**GLADSTONE PLANNING COMMISSION AGENDA
GLADSTONE CITY HALL, 525 PORTLAND AVENUE**

STAFF REPORT LAND DIVISION IN THE WQRA/HCAD DISTRICT

FILE NUMBER: Z0334-13-M
APPLICANT: Clackamas River Properties
DATE: September 11, 2013

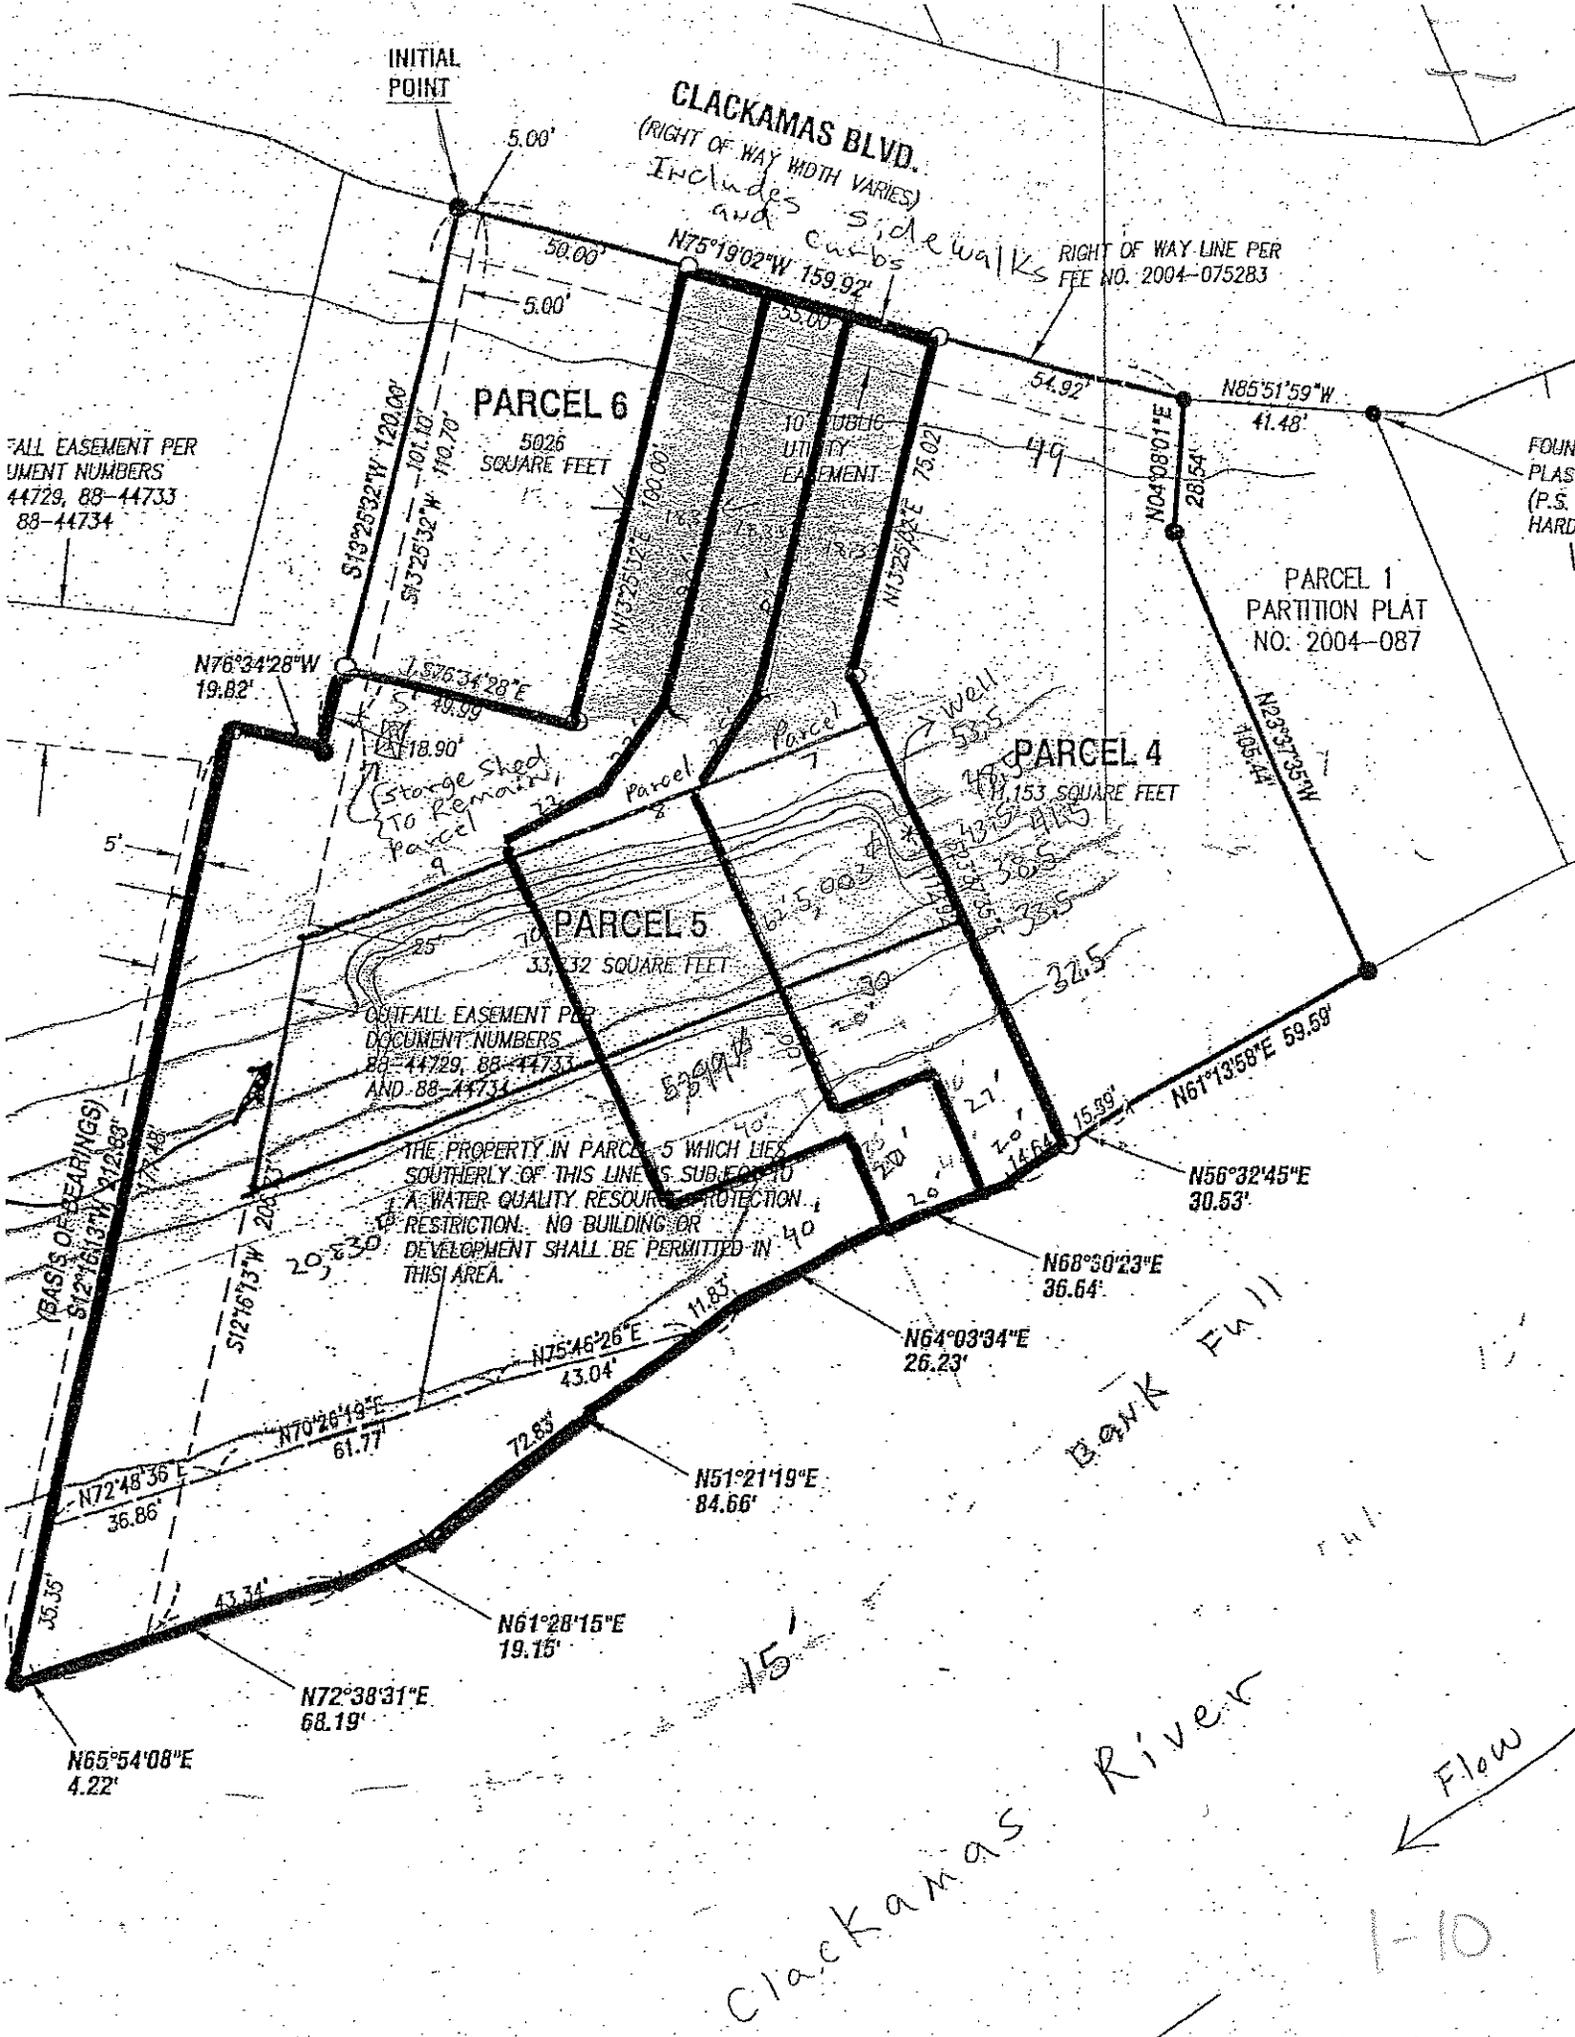
Apparently individual driveways are proposed. This may be problematic from an emergency services point of view (see comments from Fire Marshal later in this report) and also does not promote “least amount of impervious service necessary to adequately serve....”. This should be discussed by the Planning Commission.

- I. *Chapter 17.64 of the GMC* identifies the design standards for land divisions. The proposed lots generally comply with the minimum lot width and depth requirements of this chapter. At 17.64.030(2) the code states that, a lot shall have a minimum frontage of twenty feet (20') on a street other than an alley. As currently shown this criterion is not met. The Planning Commission should discuss this issue at hearing.

in 25-foot increments away from the water feature until slope is less than 25% or a point 150 feet from the starting point of measurement, whichever occurs first. For setbacks see Table I in Chapter 17.27. Information available from previous actions on the subject property, including two (2) previous land divisions, grading permits and information submitted to the State varies with regards to both bankfull stage and slope break. Depending on which data is used, approval of this partitioning may result in creation of three (3) un-buildable lots. This would be inconsistent with Title 17 of the GMC generally, and not allowed.

Water Environment Services (WES), Don Kemp in comments dated 9-5-13: Tri-City sanitary district has an outfall easement within the westerly boundary of the proposed partition. The easement should be noted on any future partition plat. We will want to look at the site plans just to make sure they are not planning any retaining walls, excavation or fill over the outfall pipe.

Fire Marshal, Michael Funk: The access to each of the newly proposed lots is the main concern. The concern is long and narrow thus limiting fire department access in the event of an emergency. The fire department is not suggesting denying this application but rather being up front and very clear with the developer on the access concerns. The new access to each property is approximately 18 and one half feet. If a car is parked at any area along this narrow access point, it will most likely block fire department emergency access. The fire engine can be placed on Clackamas Blvd. for firefighting purposes but then the placement of the new home will be limited. All points of the exterior of the home shall be not more than 150' from where the fire engine is parked on the street. Other concerns arise if the home is placed legally within the 150' maximum travel distance, but there is second or third story on the home. Again fire protection would be difficult. I would encourage the developer to sprinkler the new homes as a fire safety measure due to difficult accessibility issues.

4. All development shall satisfy requirements of the Gladstone Fire Department, to include residential sprinkler systems in each new home as discussed by the Fire Marshal.

6. Development to satisfy concerns and conditions of Water Environment Services (WES). Tri-City sanitary district has an outfall easement within the westerly boundary of the proposed partition. The easement should be noted on any future partition plat. Prior to recoding of final plat, WES to review the site plans to ensure there are no retaining walls, excavation or fill over the outfall pipe

10. The water quality resource area shall be platted as a tract, and be identified as either private open space or public open space if the tract has been dedicated to a governmental unit by mutual agreement.
